BAYWOODS PD REPLAT

SUMMARY

<p>Owner Kenneth Goldring Baywoods Orlando, LLC</p> <p>Applicant David A. White PEC-Surveying & Mapping</p> <p>Project Planner TeNeika Neasman</p>	<p>Property Location: 6540 Lake Underhill Rd. (north of Autumnvale Dr., south of Lake Underhill Rd., east of Brockway Ave., and west of Egan Dr.; PID: 35-22-30-6400-02-441) (±107.8 acres, District 2)</p> <p>Applicant's Request: Request for a Minor Subdivision replat to combine the existing two (2) residential lots into one for future residential development.</p>	<p>Staff's Recommendation: Approval of the request, subject to the conditions in this report.</p>
<p>Updated: August 3, 2015</p>

PROPOSED PLAT

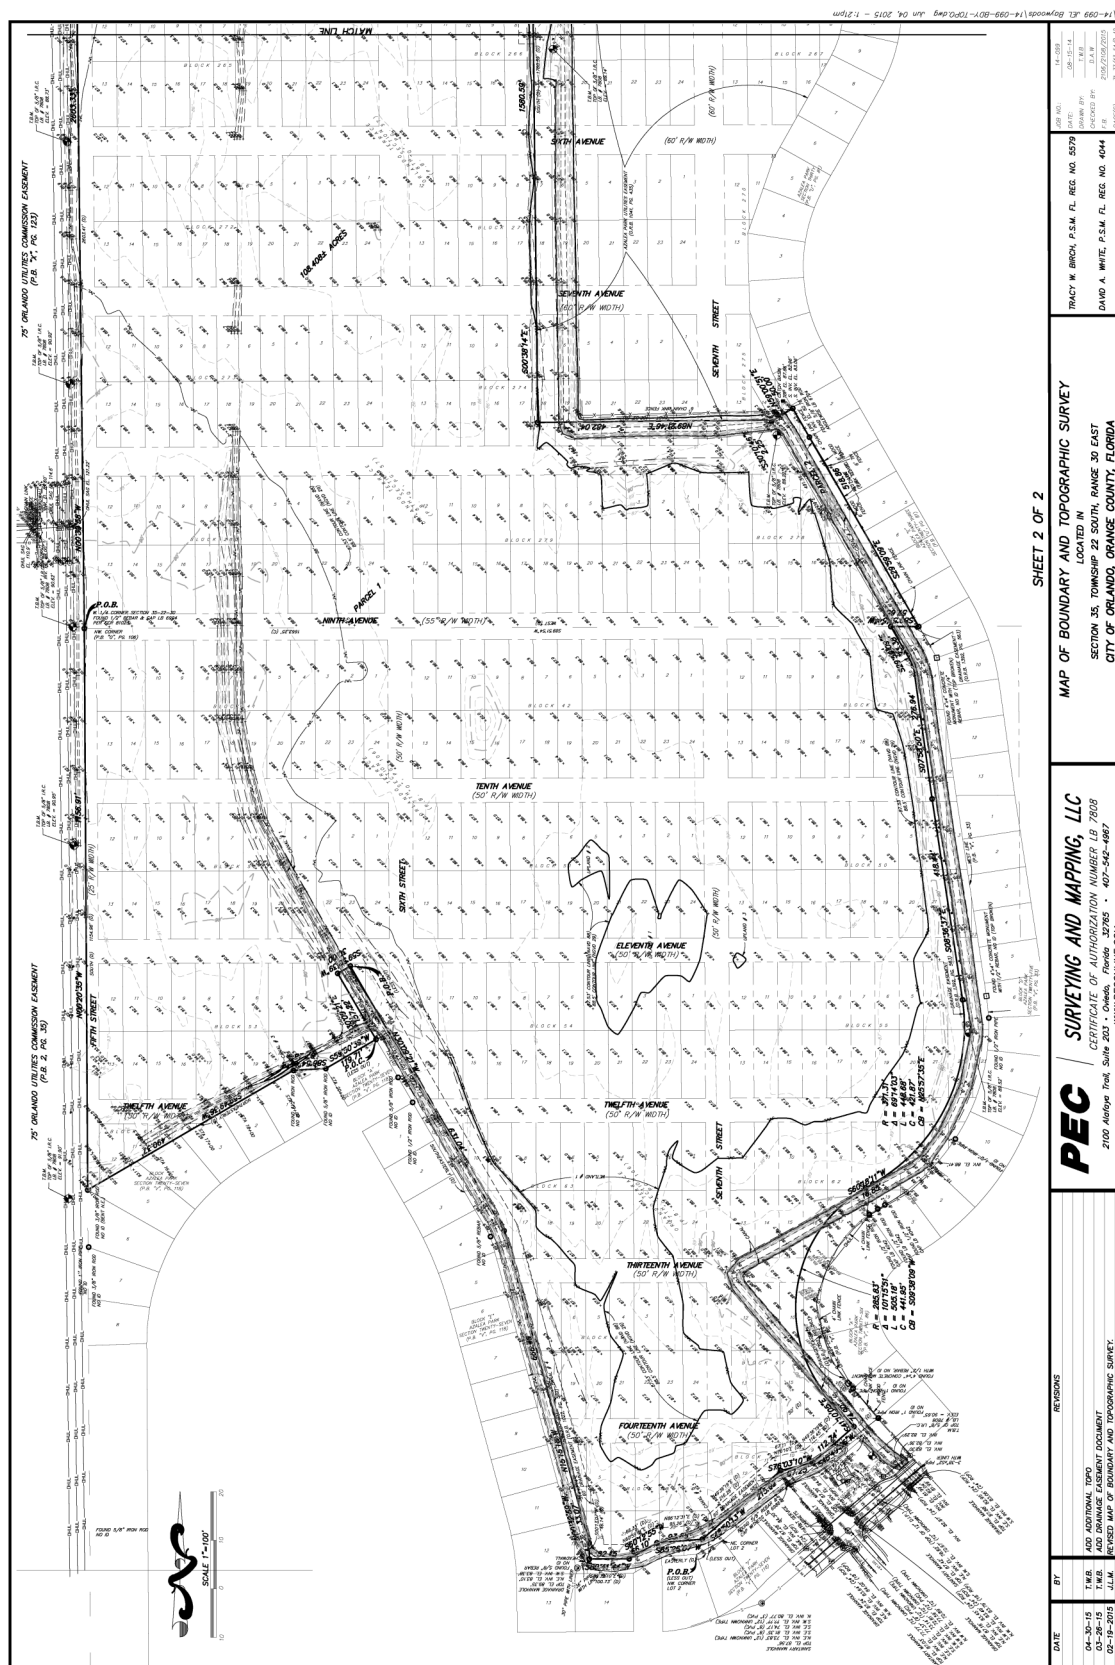
3. Easement-Encroachment. The final plat shall contain the following note: There shall be no building encroachment, roof-overhang or underground structure in the easement.

8. Concurrency Management- Plat. The final recorded plat shall contain the following note: "Development on the property depicted on this plat is subject to the requirements of Chapter 59, the Concurrency Management Ordinance of the City of Orlando, which governs the City's ability to issue building permits on this property. Approval of this application shall not be deemed to provide any vested rights, except as to those matters depicted hereon, that are consistent with the requirements of Chapter 177, Florida Statutes, or were required by the City of Orlando as a condition of platting."

1. The word "the" is misspelled in the notary block.
